Access Compliance Report

Public Rights-of-Way

| Intersection ID: 6485 | Main Street: CATHEY_RD | Cross Street: FIELDING_RD | Location: | N |
| ADA ID: 0CD2D3A888DE | Ramp Type: Perp | Initial Pass/Fail: Fail | Overall Compliance: No | Severity Score: 10 |

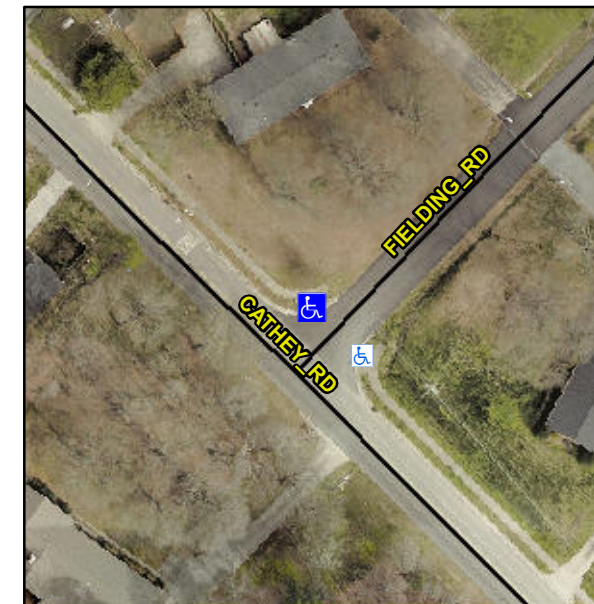
R304.5.1, R304.5.3

| Compliance | Description | Data | Compliance | Description | Data |
|------------|-----------------------|-------|------------|-----------------------------|------|
| No | Ramp Width (in) | 47.5 | No | Ramp XSlope (%) | 3.1 |

Remove & Replace Entire Ramp.
